FIELD SERVICE CAMPAIGN – 16123

Bus Door Rework – Add Backup Plate to Stop Tab

CE Bus, RE Bus

Figure 2. Stop Tab

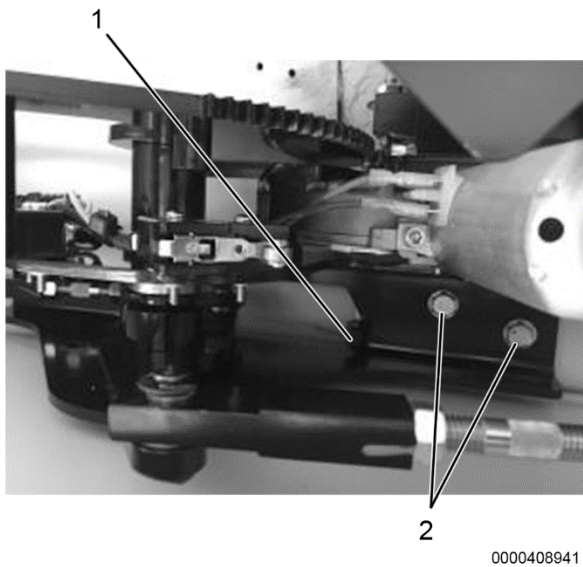
1. Tab
 2. Bolt (2)
7. Rotate entry doors to about halfway closed. This will allow clearance between bell crank and stop tab (Figure 2, Item 1).
 8. Inspect door module mechanism to determine if Support Bracket (Figure 3, Item 2) has already been installed.
 - a. If bracket is present, proceed to Step 14.
 - b. If bracket is not present, proceed to Step 9.
 9. Using an adjustable wrench, bend stop tab back to approximately 11 degrees from perpendicular.
 10. Remove two bolts (Figure 2, Item 2) on right side of door module. Save fasteners for reuse.

Figure 3. Support Bracket

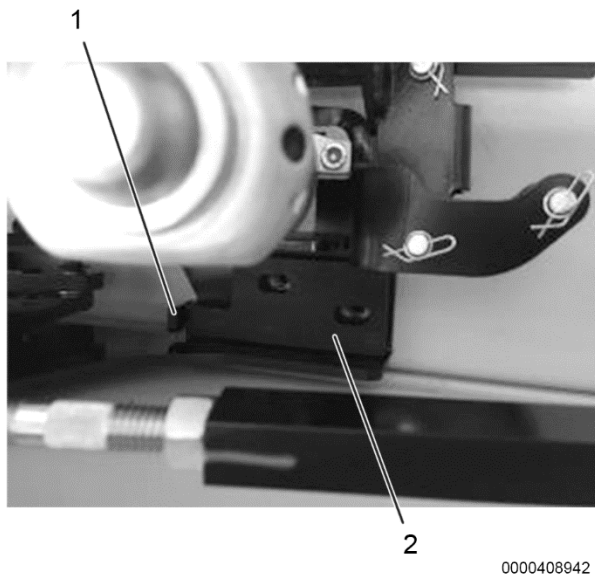
11. Place support bracket (Figure 3, Item 2) into position and slide to left against stop tab (Figure 3, Item 1).
12. Hold bracket in place and loosely install previously removed bolts (Figure 2, Item 2).
13. Using a torque wrench, tighten the two reinstalled bolts to 21 - 27 lb-ft (28 - 37 N•m).
14. Move red handle to the right.
15. Turn ignition key to accessory position and push OPEN button to actuate door.

Figure 4. Top Pin

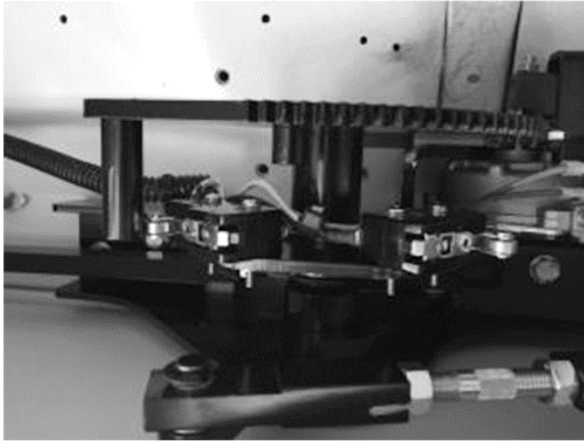
16. Once door is fully open, verify motor is off and that top pin is contacting switch (Figure 4). If pin is not contacting switch, repeat Step 9, readjust support bracket to contact stop tab, and retest door operation.
